# Street Tree Review Panel Report for A38 BREP Scheme C

## Summary of Scheme C Proposals:

## Comments from Street Tree Review Panel

### **Stoke Road on slip**

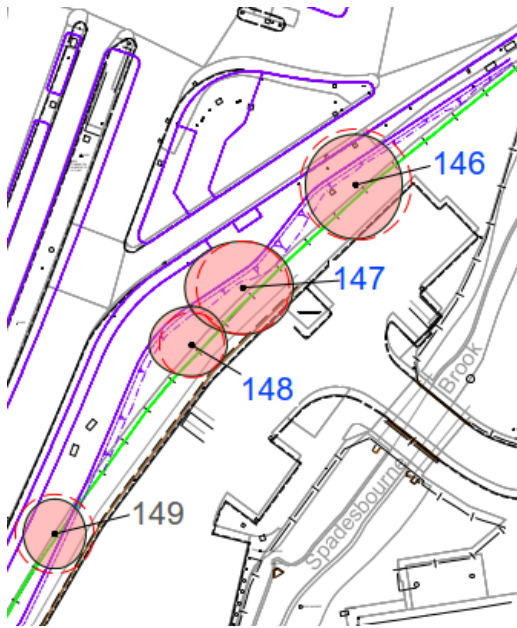
A new Active travel corridor shall be implemented adjacent to the slip road. Tree 149 shall need to be removed as it is within the works. The remaining three trees were due to be removed. However, the Arboriculturist has agreed that retention may be possible if suitable mitigation measures are carried out. The trees will be assessed on site by a qualified arboriculturist.

Trees 146, 147 and 148 on the Stoke Road on slip shall be changed from “removal” to “at risk of damage/removal” and will be subject to an on-site assessment by the Arboriculturist.
